5/15/78

TO: JIM SEELINGER

SUBJ: Water in Service air & hot air

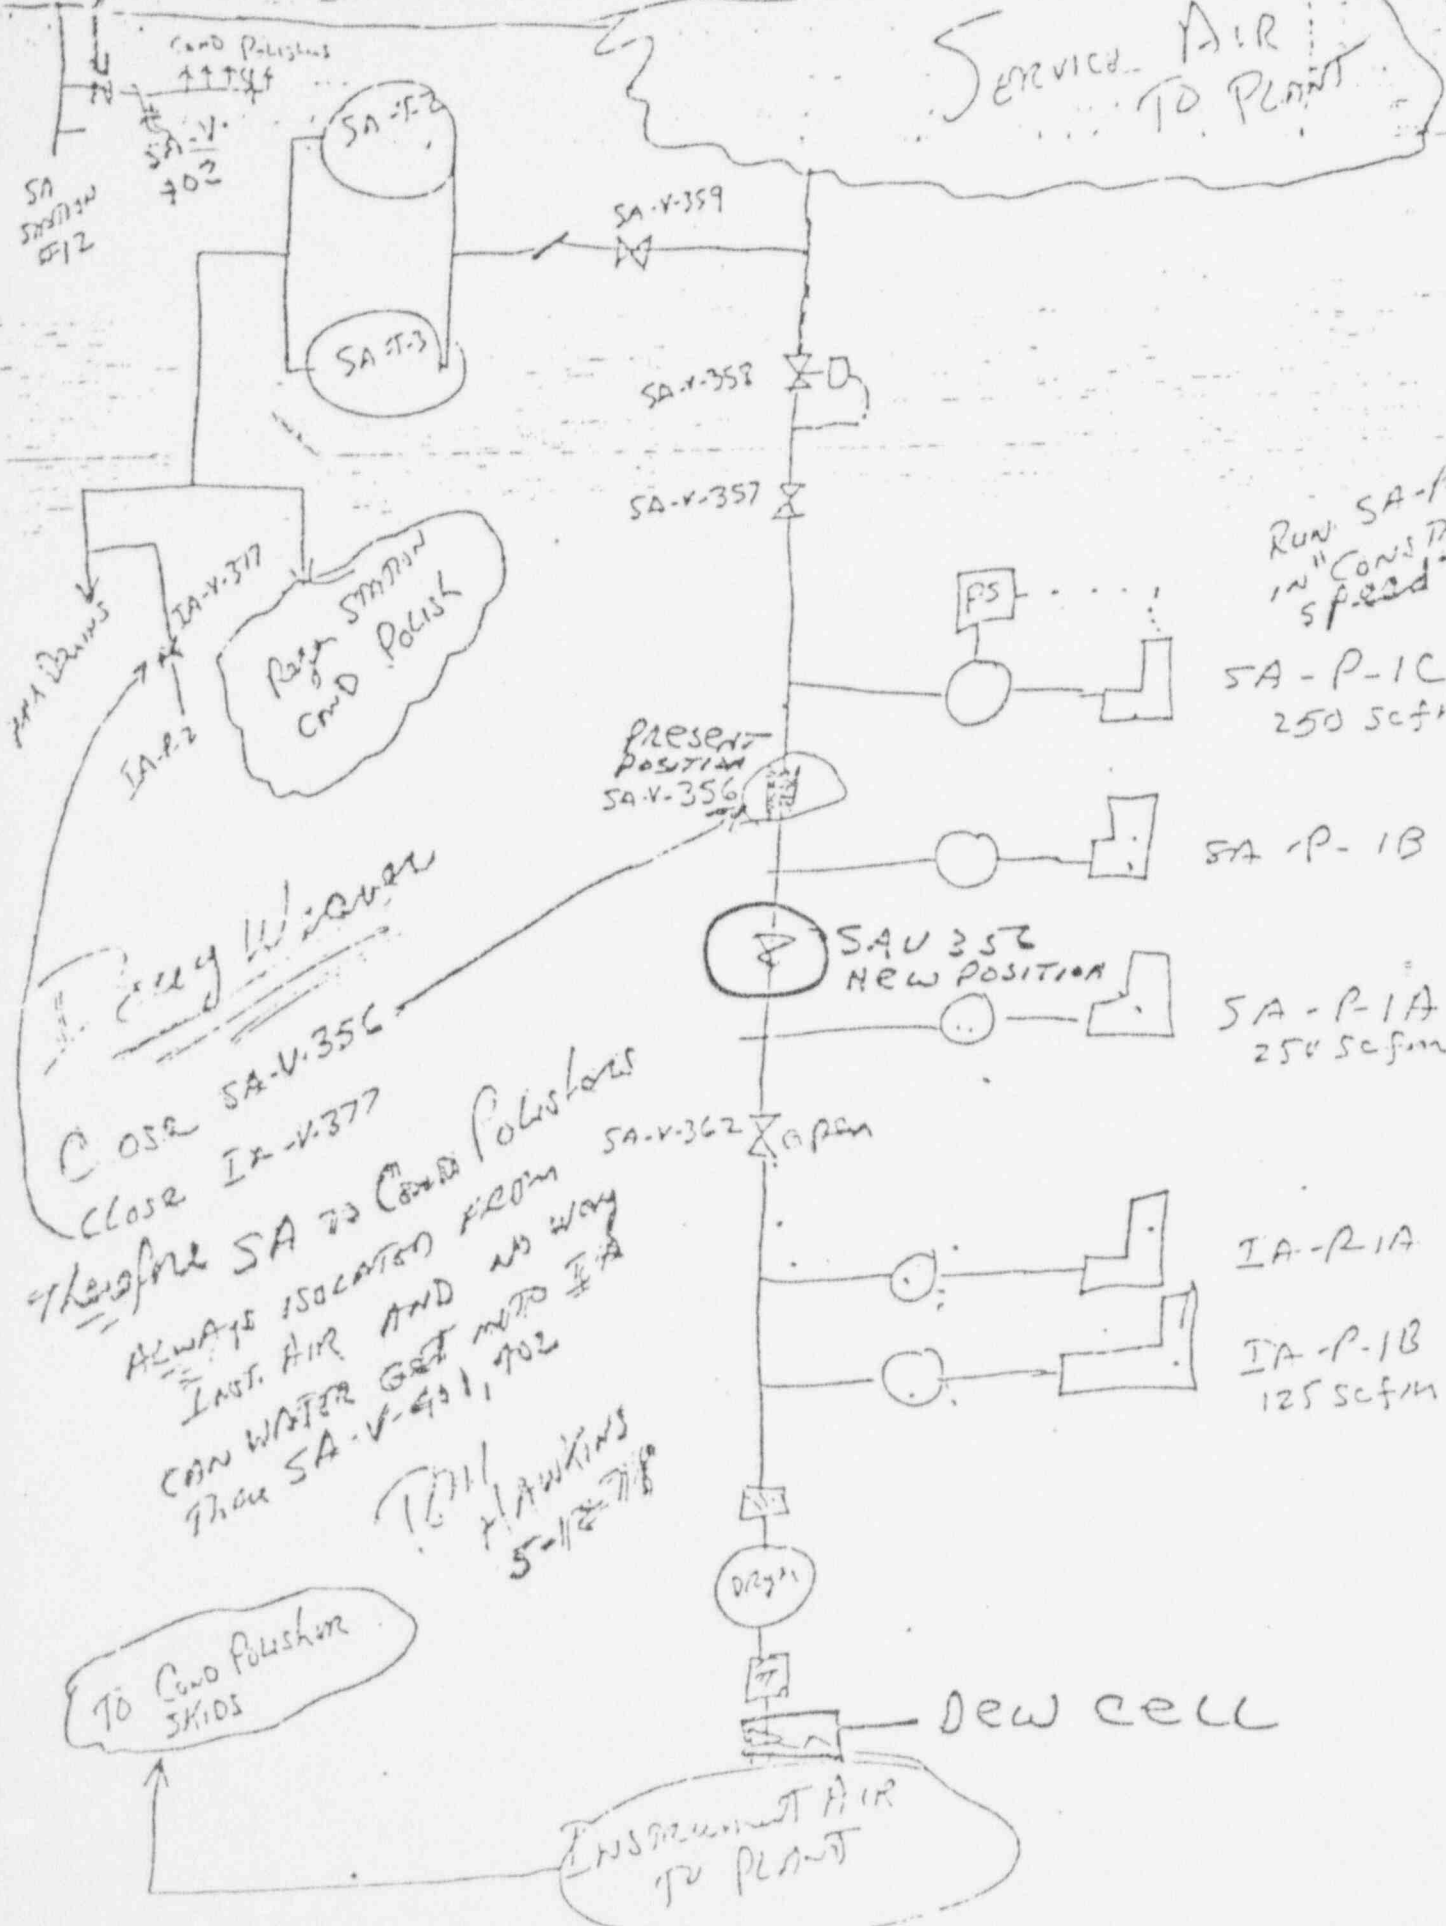
It's time to really do something on this problem before a very serious accident occurs. If the Poliskens take themselves off line at any high power level the resultant damage could be very significant.

1. CDV12 - must be made an automatic valve that ~~opens~~ on High Poliskens DP
OPENS

2. SAV 356 - Move valve to between SA-P-1A and SA-P-1A. Keep this valve shut at all times to isolate SA. & I.A.

3. Install inline dew cell instrument downstream of air dryer. This should be made to alarm and record.

Run SA-P-1C in "CONSTANT speed"

Close SA-V-356
Close IA-V-377

Therefore SA to COND POLISH
Always isolated from
Inst. Air and no way
can water get into IA
thru SA-V-431, 402
